**NOTICE OF
SPECIAL MEETING OF THE PLANNING AND ZONING COMMISSION
HICKORY CREEK TOWN HALL
1075 RONALD REAGAN AVENUE, HICKORY CREEK, TEXAS 75065
TUESDAY, MAY 05, 2026, 6:00 PM**

Project Name: 104 Carlisle – Hickory Creek Addition

**Re: HTeaO Store #395 – 3080 FM 2181 (Lot 2B, Block A – Lennon II Addition)
Site Plan and Landscape Plan
1st Review**

SHEET NUMBER
LS1.00

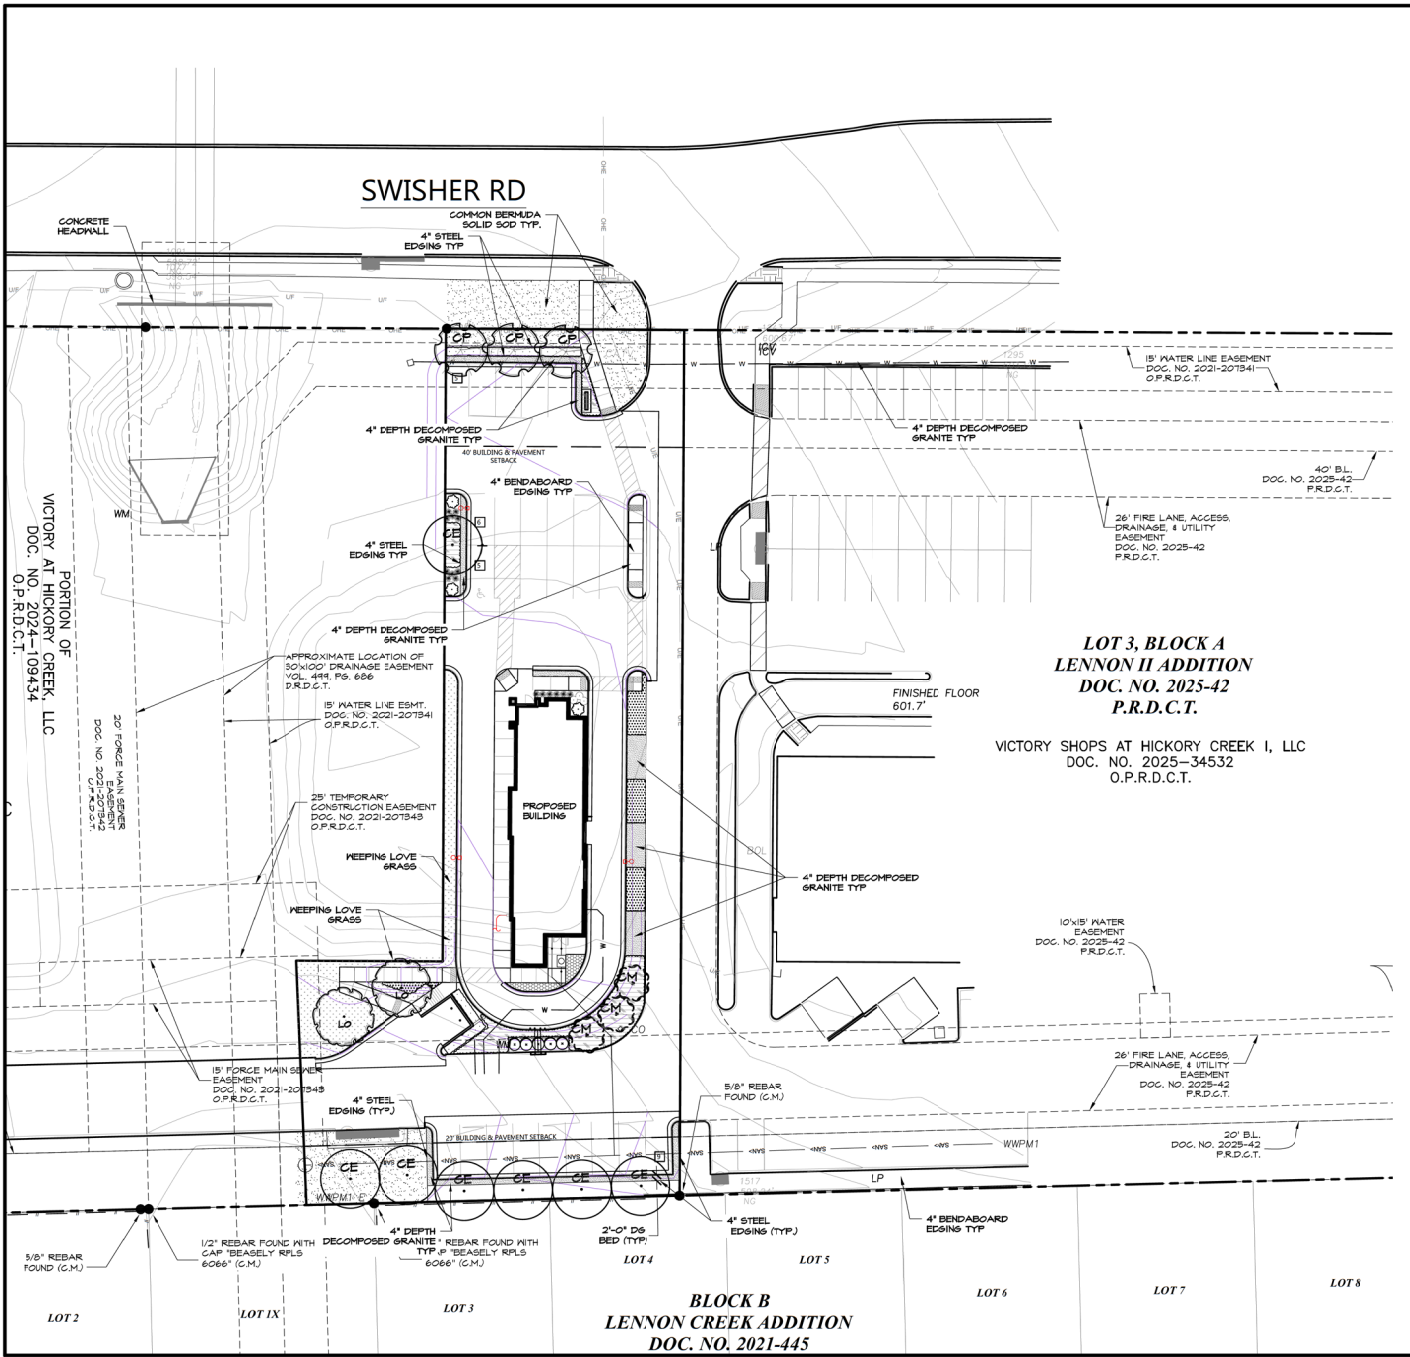
1. Please show and label all screening walls, fences, retaining walls, headlight screens and service area screens, including heights and types, as needed on the Landscape Plan. Refer to Site Plan comment regarding required masonry screen wall along southern boundary.

SHEET NUMBER
C1.1

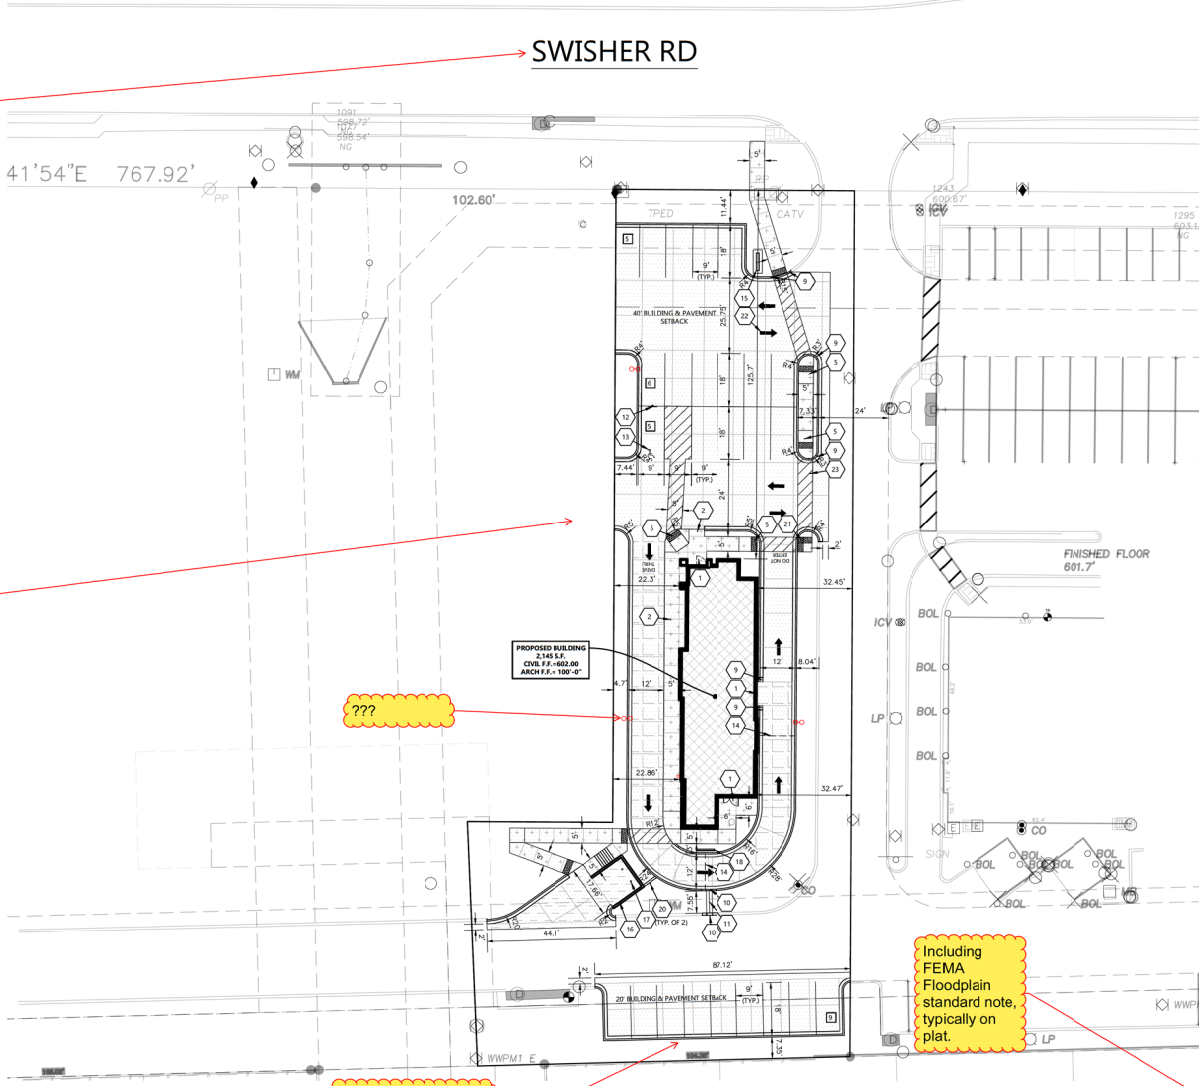
1. For the Title Block, please include the Addition name with Lot and Block number, Acreage, Survey Name and Abstract, and County as appropriate.
2. Please include the contact information for the Owner/Developer on the Site Plan.
3. Please include the FEMA Floodplain standard note, typically shown on platting.
4. Please show or verify intent for screening wall at the back of the lot given proximity to residential zoning and as required of the other commercial lots on this Block.

5. Please show or verify intent for water line, sewer services, fire hydrants, and drainage on site.
6. Please add a Vicinity Map on the Site Plan.

Add acreage
to title block

Revise street
label to mark
as FM 2181
given the site
address

Missing Information on:
-Water Lines
-Sewer Services
-Fire Hydrants
-Storm Drain
Or provide clarification

???

Including
FEMA
Floodplain
standard note,
typically on
plat.
